**Re: Jackson Hydroelectric Project (FERC No. P-2157-188) –
Response to Deficiency and Additional Information Request**

Schedule A – Deficiency

Schedule B Additional Information Request

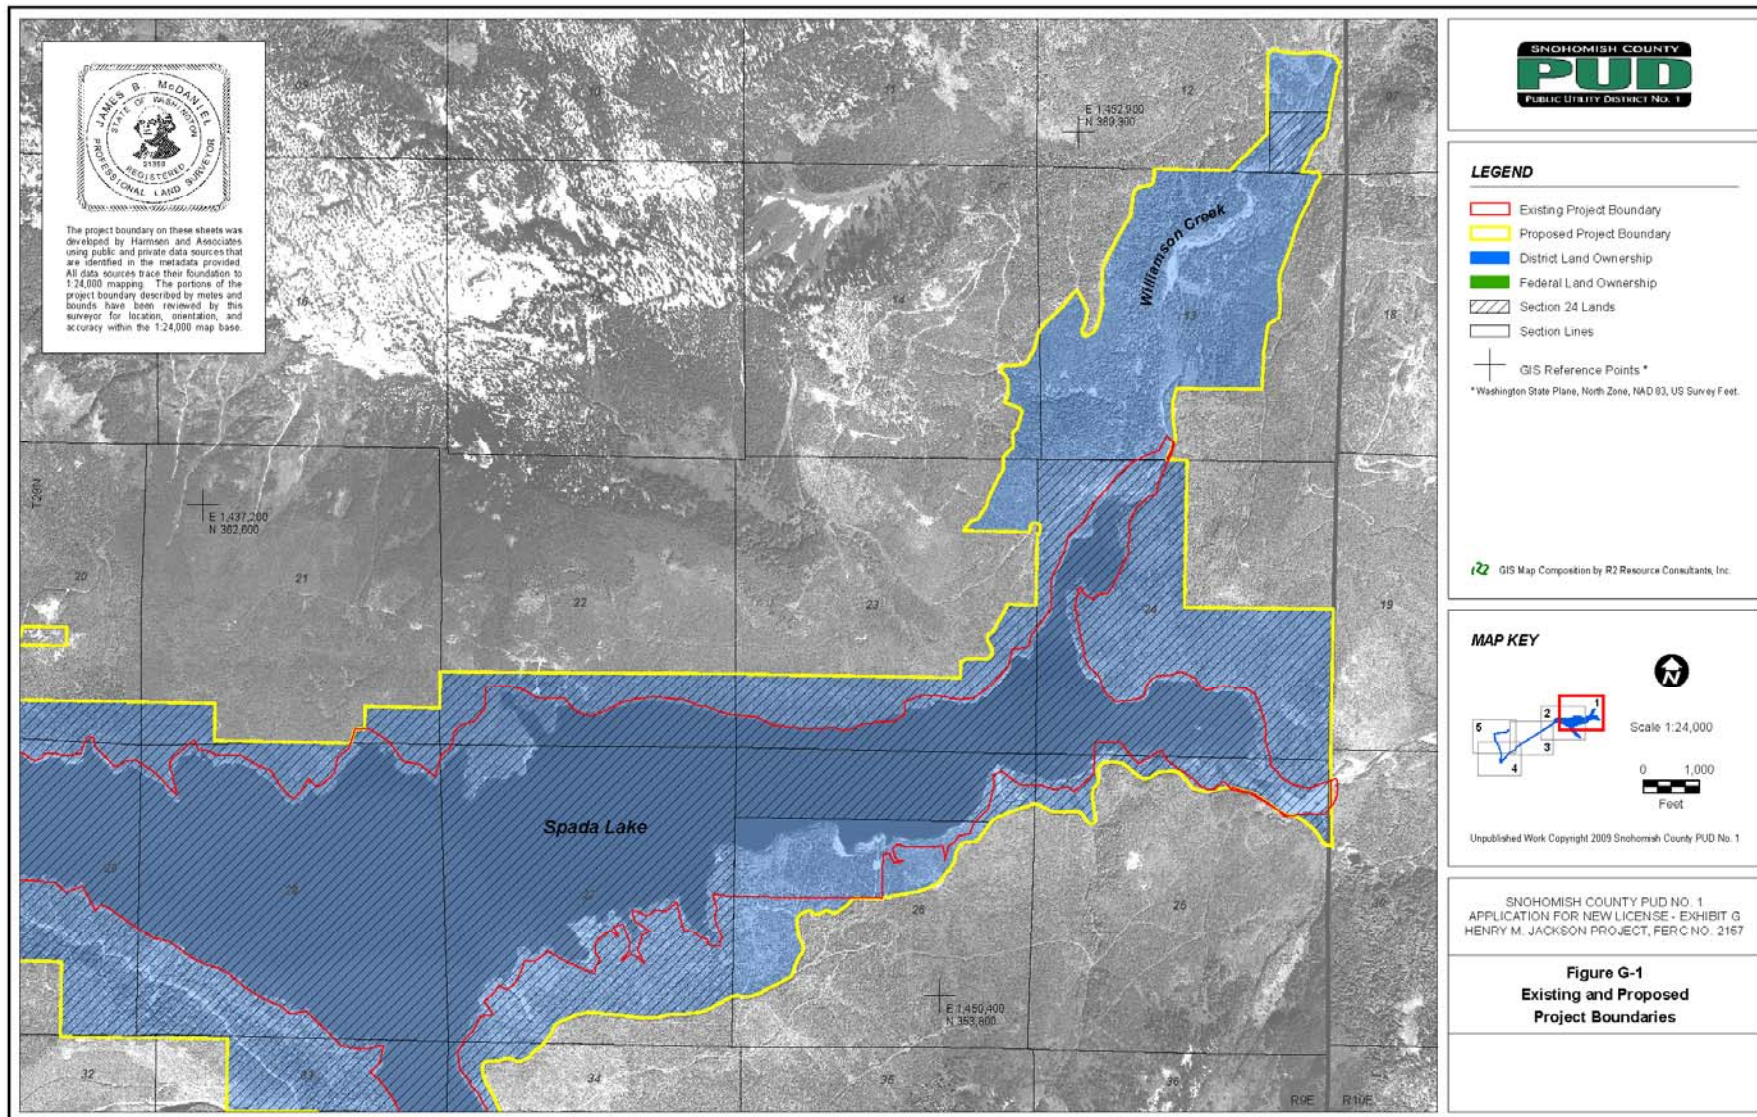
In addition, the available information suggests that the greatest amount of whitewater boating use is most likely to occur in and below segment 2. The U.S. Forest Service recommended that you construct and maintain an alternate trail access for whitewater boaters. So that we may evaluate the benefits and cost of alternatives to your proposed access site, please provide the following information: (a) a description of an alternative whitewater boating trail and access site that could be located between segment 1 and segment 2; (b) a map that clearly shows the site in relation to the project boundary; (c) the land ownership and site size (acres); (d) the potential improvements to the site necessary to provide access, and the associated costs; (e) documentation of consultation, including comments from the U.S. Forest Service, Washington Department of Fish and Wildlife, any affected miners, and American Whitewater on your response.

This trail is on NFSL. It is approximately 1.2 miles in total - 0.6 miles along the 6122 Road beginning at the boundary of District land and NFSL, and approximately 0.6 miles from the 6122 Road to the Sultan River. Assuming a 4-foot width along the 6122 road beginning at the boundary of District owned land and NFSL, and a 2-foot width from the 6122 road to the Sultan River it encompasses approximately 0.9 acres.

Attachment A

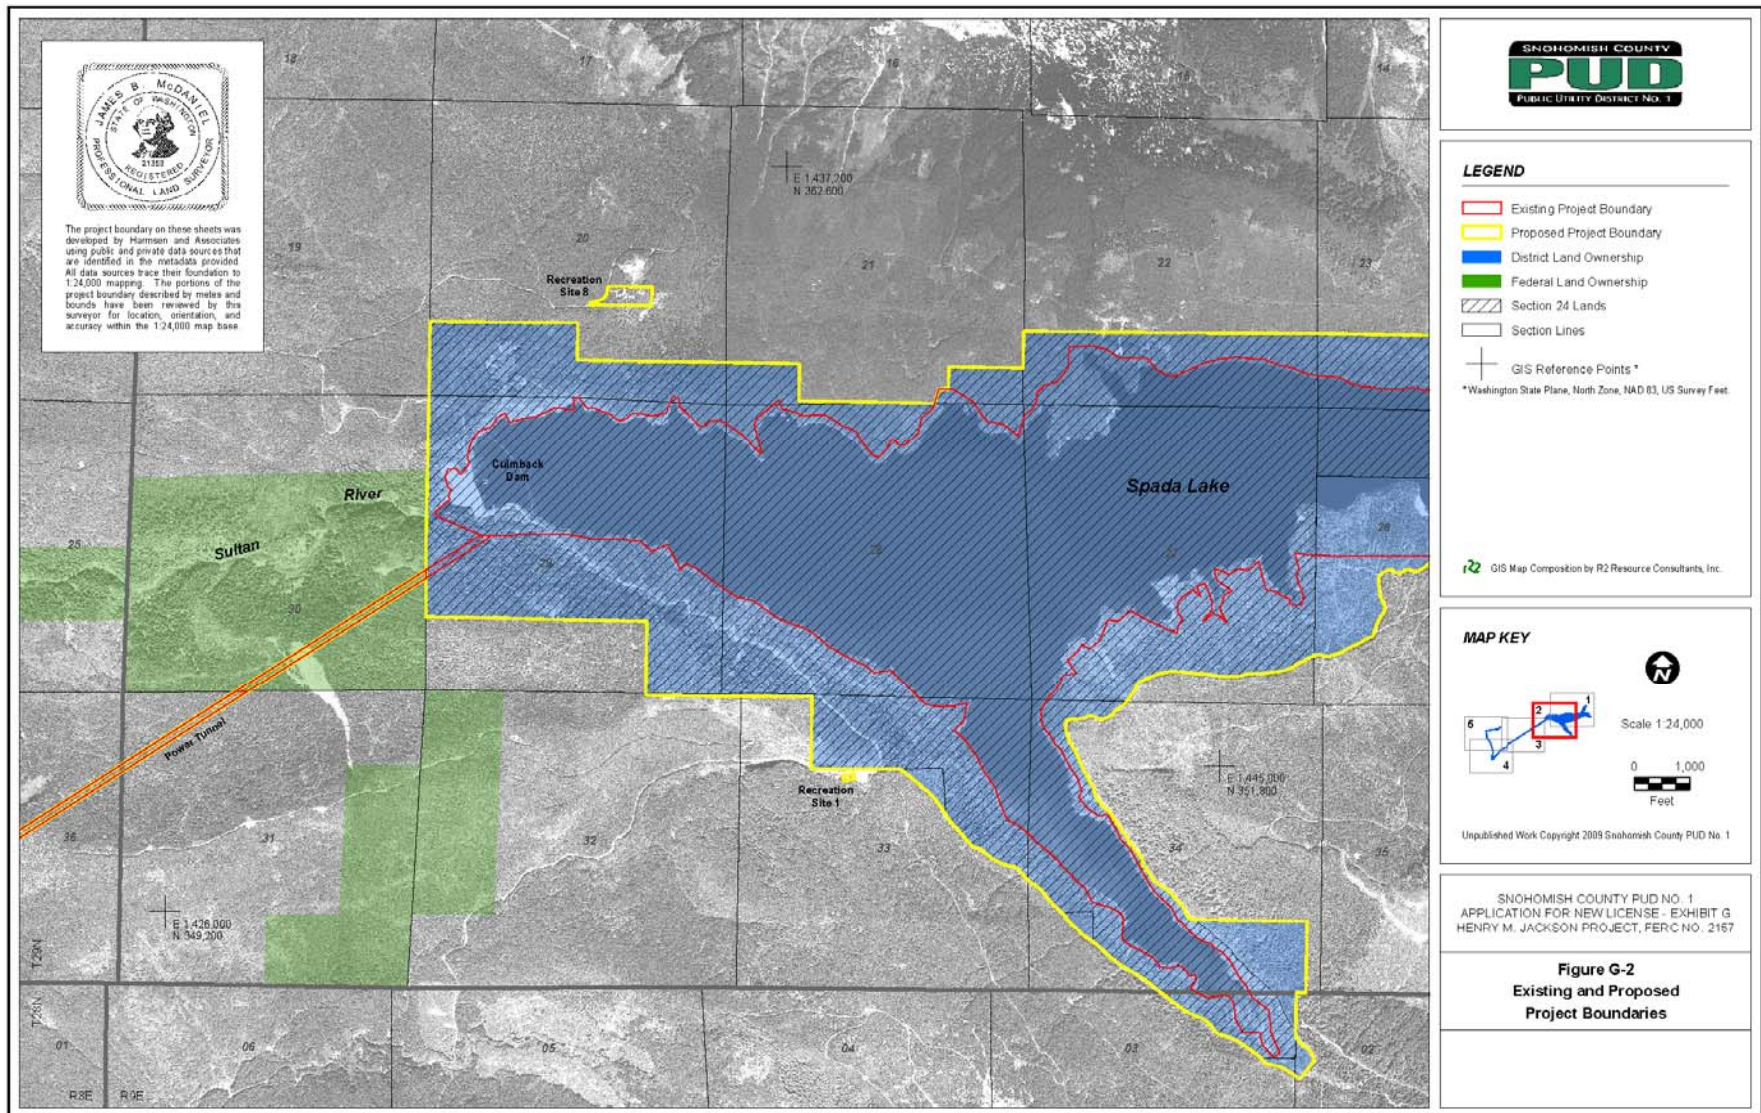
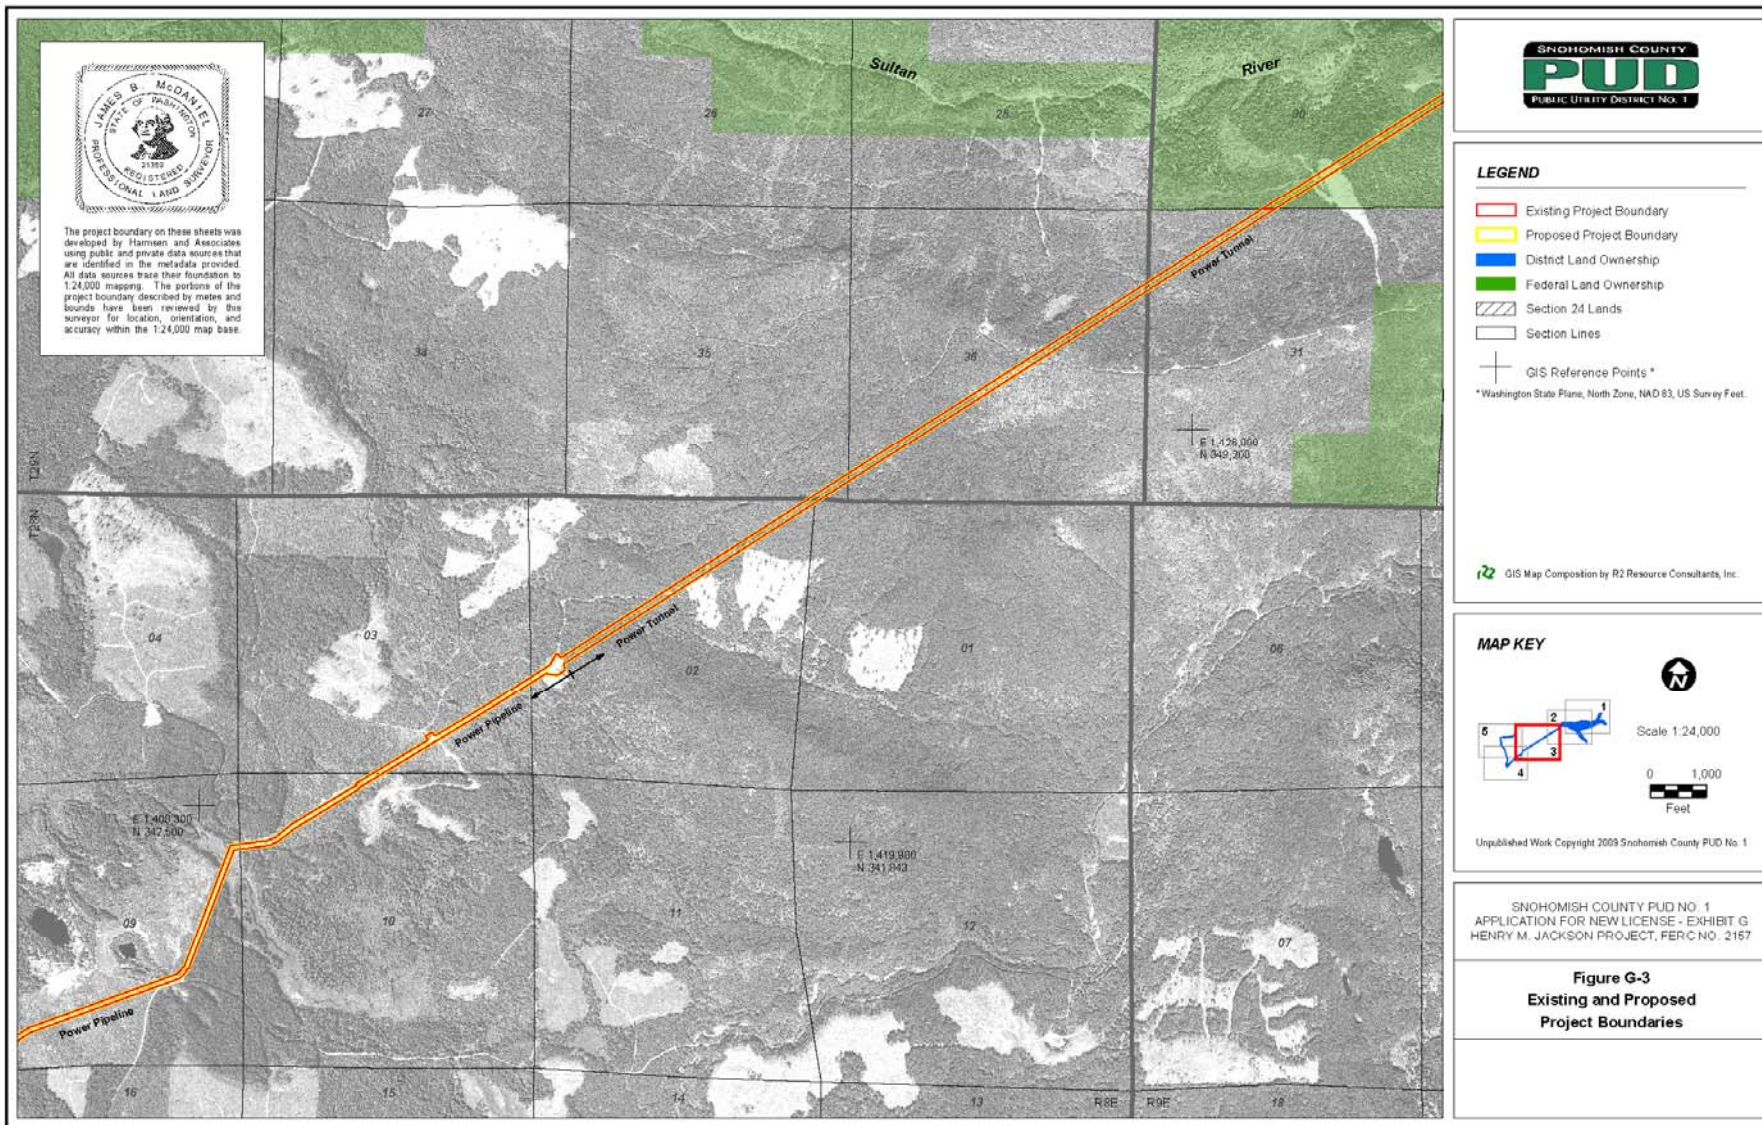
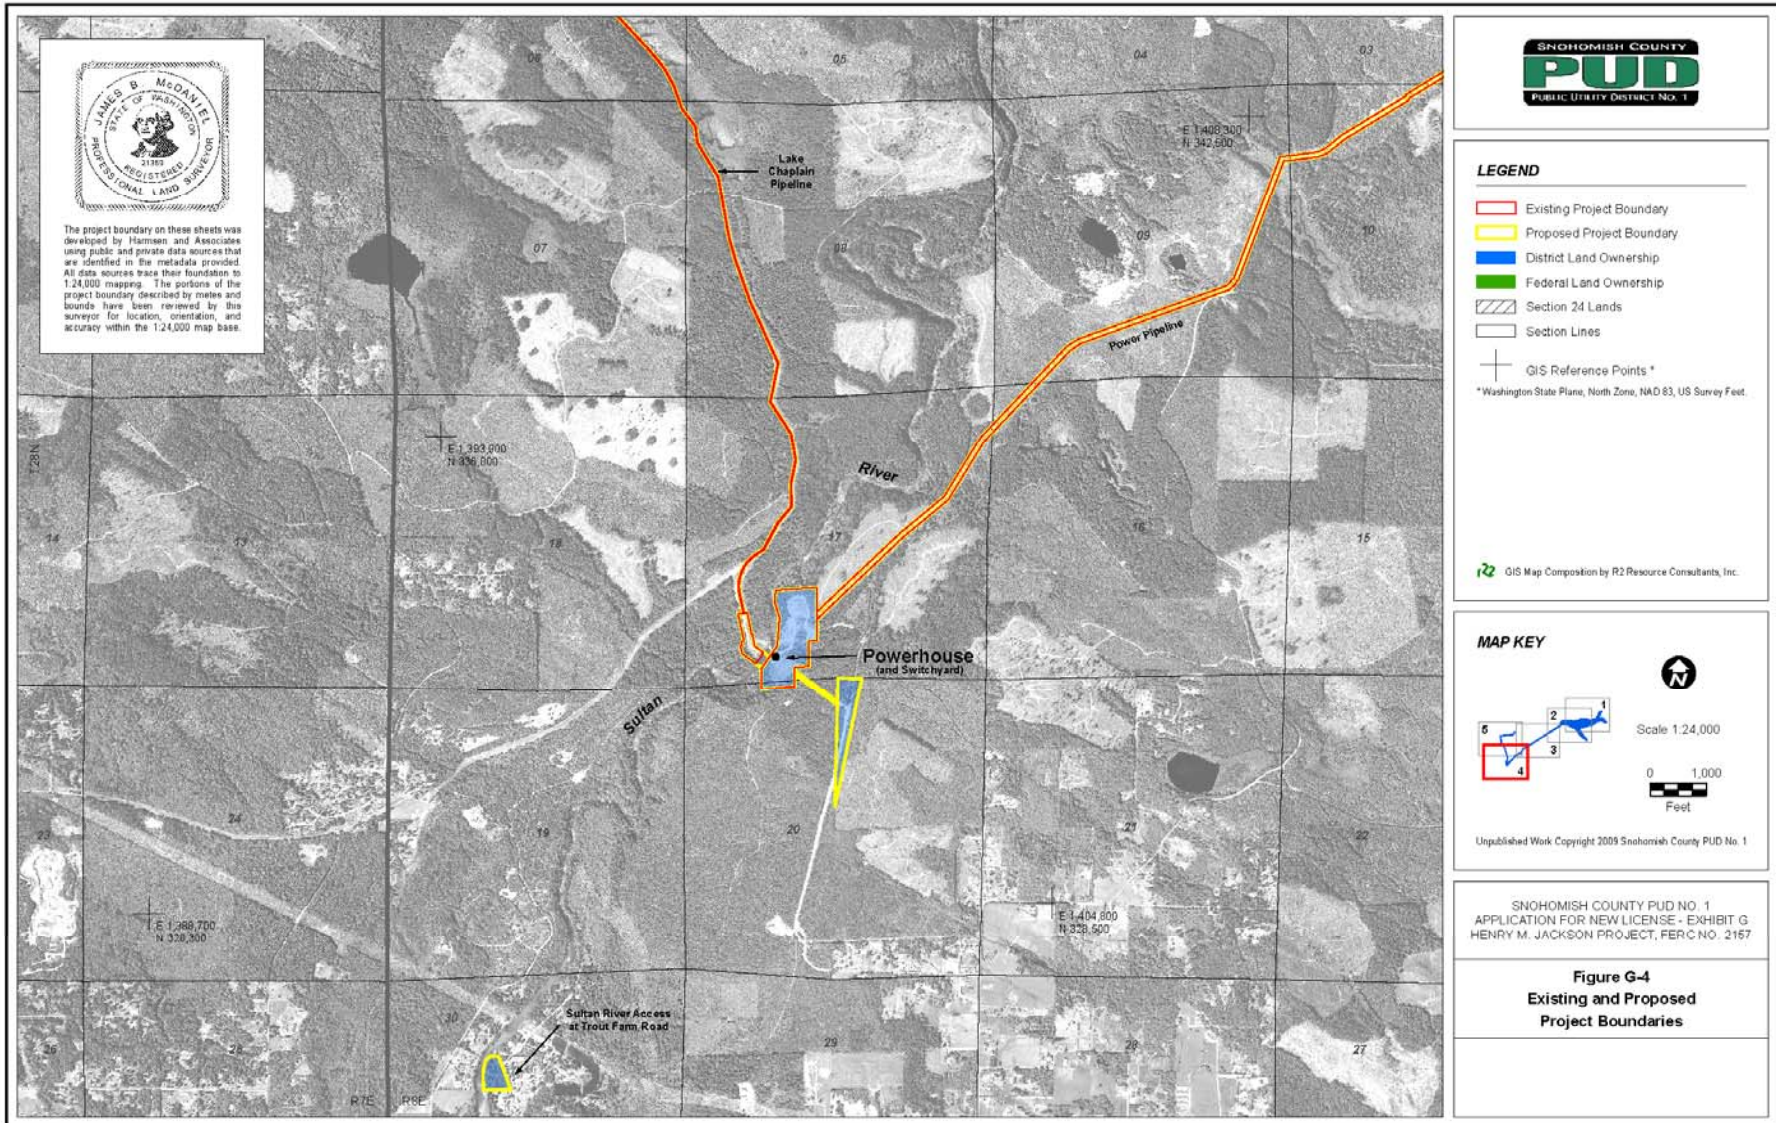
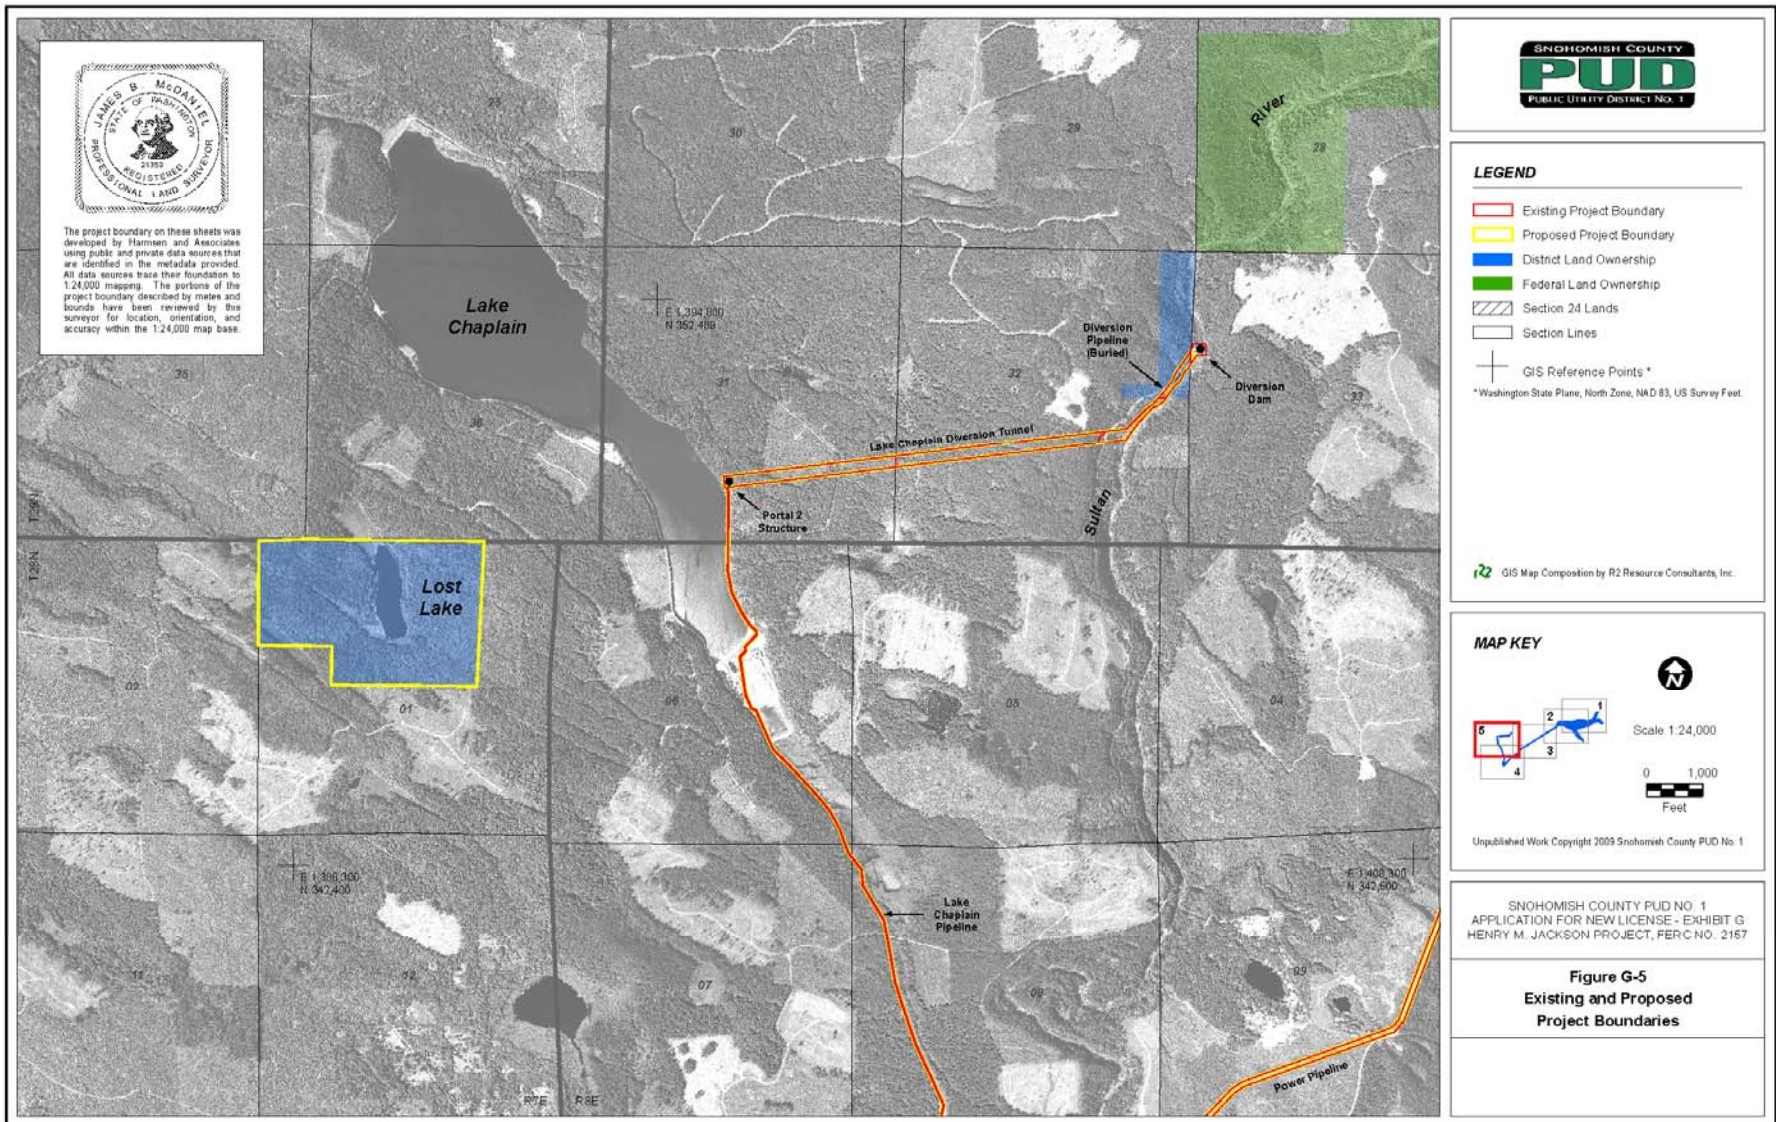
1. The Exhibit G maps were not filed in electronic formats per the Commission’s regulations (18 C.F.R. Part 4, Subpart E, Section 4.41(h)). After modifying the drawings as discussed in Schedule B, Items 7, 8 and 9, please file the drawings in the appropriate electronic formats.

7. Please identify the 3,466.7 acres of section 24 lands on the Exhibit G maps and include this information in your electronic drawing files as well as the hardcopy figures (see Schedule A, Exhibit G deficiency).

8. Exhibit G, figure G-4, shows a project boundary addition located to the southeast of the powerhouse that is not labeled. Please label the parcel based on its purpose or function. The text in Exhibit E does not provide an adequate explanation as to the purpose of the inclusion of this parcel, and does not state what project features or structures are included within the area shown. Please provide this information and ensure that the parcel to be added is limited only to lands necessary for project purposes. This request should be incorporated into your filing of electronic drawing files as well as the hardcopy figures (see Schedule A, Exhibit G deficiency).

9. Important project (and non-project) features, such as the powerhouse, switchyard, Portal 2 structure, and diversion dam, should be included on the Exhibit G maps. Per section 4.41(h)(1) of the Commission's regulations, the Exhibit G maps must show the relative locations and physical interrelationships of the principal project works as described in Exhibit A of the license application. The Exhibit G maps do not show any actual structures, only labels. Please include the footprints of the structures/features on the maps. This request should be incorporated into your filing of electronic drawing files as well as the hardcopy figures (see Schedule A, Exhibit G deficiency).

The Exhibit G maps are now included in the required electronic format. Exhibit G maps are also provided in Attachment A for reference.

The 3,466.7 acres are identified on the Exhibit G maps.

The triangular parcel southeast of the Powerhouse is owned by the District and contains no Project features or structures. It is currently managed as part of the Wildlife Habitat Management Plan. The District will continue to manage this parcel for wildlife under the new Terrestrial Resource Management Plan (TRMP).

The Exhibit G drawings have been updated to include labels of Project features and arrows pointing to their locations on the map. Please see Attachment A and the electronic data for the revised Exhibit G drawings.
